RAI Volume 3, Chapter 2.2.1.3.2, Third Set, Number 1:

Demonstrate that the drip shield retains adequate seepage barrier functionality after deformation (SAR 2.3.4.5.3).

Figure 4. Comparison of Ultimate Plastic Load Capacity (limit load) for the Drip Shield Framework and Drip Shield Crown Plates

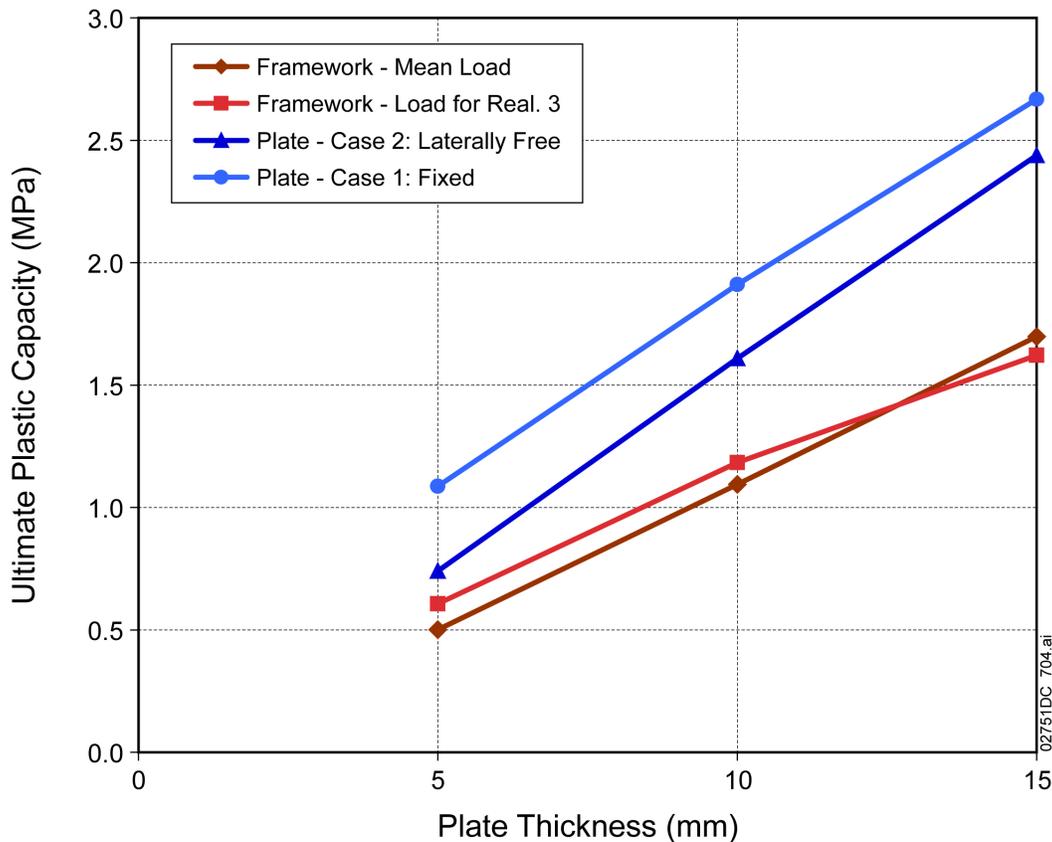
Analyses also show that for an intact drip shield framework (i.e., no uniform corrosion), the bulkhead snaps through in the middle of the crown span during failure (SAR, 2.3.4.5.3.3.2). The SAR does not explain the apparent inconsistency between the analyses used to generate the drip shield abstractions for the first tens of thousands of years, and the conclusion that the crown plates are structurally more robust than the framework legs (SAR Sections 2.3.4.5, 2.3.4.5.3.3.2, and 2.3.4.4.4.1), particularly in the context of barrier functionality.

The three-dimensional quasi-static calculations for the ultimate plastic load capacities of the drip shield framework and of the crown plates demonstrate that the crown plates are structurally more robust than the framework legs, as stated in SAR Section 2.3.4.5.3.2.3. Figure 4 provides a side-by-side comparison of the plastic load capacities, also called limit loads in the SAR, from the information in SAR Figures 2.3.4-81 and 2.3.4-83. The comparison in Figure 4 demonstrates that the plastic load capacities of the crown plates are always greater than the plastic load capacities of the framework for the three levels of corrosion thinning, providing the basis for the statement that the crown plates are structurally more robust than the framework. In addition, the difference in load capacity is consistently represented in the fragility curves for the framework and crown plates because, for a given level of corrosion thinning, the probability of rupture of the crown plates is always lower than the probability of the sidewalls buckling at a given ground motion level (SAR Tables 2.3.4-43 and 2.3.4-44).

The three-dimensional quasi-static analyses also show that the failure mode for the as-installed drip shield is snap-through of the crown at the middle of its span (SAR Figure 2.3.4-82 and SAR Section 2.3.4.5.3.3.2). This failure mode is different than the failure mode for the two-dimensional dynamic calculations discussed in SAR Section 2.3.4.5.3.3.3. As explained in Section 1.2.1 of this response, the two-dimensional dynamic calculations typically fail by buckling of a sidewall near the bottom, approximately 20 to 30 cm from the contact with the invert, rather than by snap-through of the crown (SNL 2007a, Figure 6-60). Only one case in the dynamic two-dimensional calculations, ground-motion set number 11 at the 4.07 m/s PGV level, shows indications of failure in the crown. However, these potential crown failures occur at or near the shoulder, and do not exhibit a snap-through response (SAR Figure 2.3.4-85 and SNL 2007a, Section 6.4.4.6, Figures 6-60, 6-61, and 6-62). In this situation, any seepage through these crown failures would flow down the side of the drip shield and not cause advective releases from the waste packages.
